# Access Compliance Report

## Public Rights-of-Way

### (Curb Ramps)

Intersection ID: 49389	Main Street: AUBRAC_LN	Cross Street: SHORTHORN_ST	Location: NW
ADA ID: B7B416F995C8	Ramp Type: PerpDiag	Initial Pass/Fail: Fail	Overall Compliance: No
Severity Score: 22.5			
Codes/Mitigation Info/Possible Solution		Field Measurements/Component Compliance

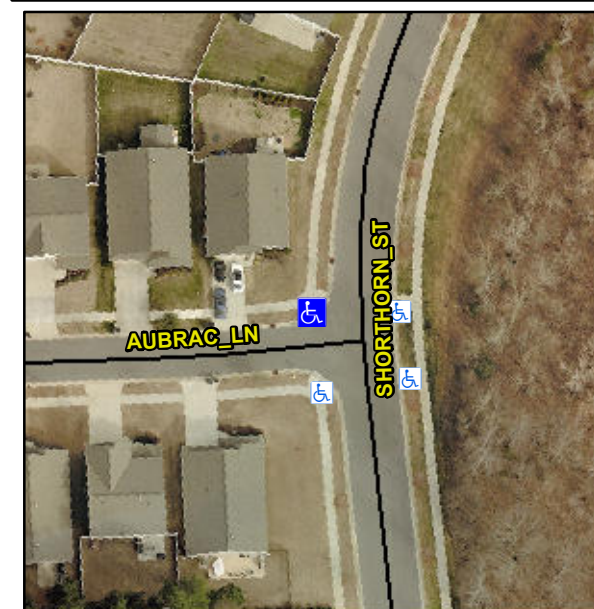
**Remove & Replace Curb Ramp With Two New Directional Ramps or Equivalent.**

**R304.5.1, R304.2.2, R304.5.3**

Compliance	Description	Data	Compliance	Description	Data
N/A	Ramp Length (in)	75.0	No	Ramp Slope (%)	11.7
No	Ramp Width (in)	47.5	No	Ramp XSlope (%)	3.1
N/A	Flare Type LT	N/A	N/A	Flare Type RT	N/A
N/A	Flare Slope LT (%)	N/A	N/A	Flare Slope RT (%)	N/A
N/A	Flare Traversable LT?	N/A	N/A	Flare Traversable RT?	N/A
N/A	Landing Length (in)	N/A	N/A	DWS Provided?	N/A
N/A	Landing Width (in)	N/A	N/A	DWS Contrast?	N/A
N/A	Landing Slope (%)	N/A	N/A	DWS Length (in)	N/A
N/A	Landing X Slope (%)	N/A	N/A	DWS Full Width?	N/A
N/A	Landing Curb? (Y/N)	N/A	N/A	DWS Offset (in)	N/A
N/A	Shared Landing?	N/A			
N/A	Gutter Ponding?	N/A	N/A	Gutter Slope (%)	N/A
N/A	Gutter Lip Ht (in)	N/A	N/A	Gutter X Slope (%)	N/A
N/A	Painted X Walk1?	No	N/A	Painted X Walk2?	No
	X Walk 1 Direction	To S		X Walk 2 Direction	To E
N/A	X Walk 1 Width (in)	N/A	N/A	X Walk 2 Width (in)	N/A
	X Walk 1 Slope (%)	1.4		X Walk 2 Slope (%)	2.1
	X Walk 1 X Slope (%)	2.1		X Walk 2 X Slope (%)	2.8
